Title of Change:	NCP81075 datasheet specification update
Effective date:	15 Sep 2024
Contact information:	Contact your local onsemi Sales Office or KH.Lee@onsemi.com
Type of notification:	This Product Bulletin is for notification purposes only. onsemi will proceed with implementation of this change upon publication of this Product Bulletin.
Change Category:	Datasheet Specification Update
Change Sub-Category(s):	Datasheet Specification Update

The purpose of this notification is to inform customers about NCP81075 product datasheet update on the following sections;

FIGURE 4: Propagation Delay Timing Diagram

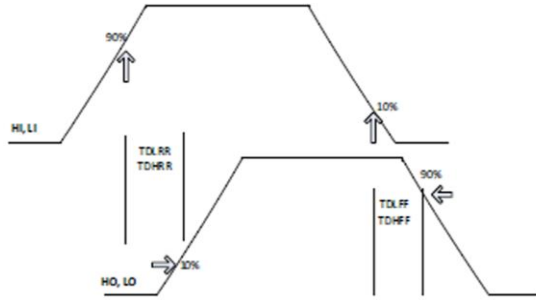
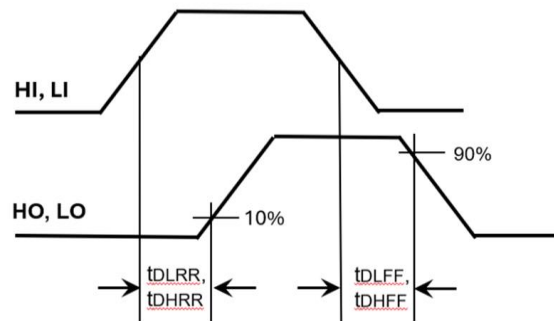
- Change in min, typ and max spec for propagation delay parameters. Figure 12 and 13 were updated in relation to this change.
- The -40 to 125°C EC table lines in propagation delay parameters were already covered by the wider -40 to 140°C spec, so the redundant lines were eliminated.”
- Change in min, typ and max spec for output delay matching parameters
- Provide clarity on UVLO (tDUVLO) delay time in relation to VDD slew rate. Fig 2 is updated to show this relationship.
- Updated tMON and tMOFF timing diagram (Fig 3) to show overlap in both edges. Figure 4 is updated in relation to tMON and tMOFF changes as well as Fig 6 to show response over temperature
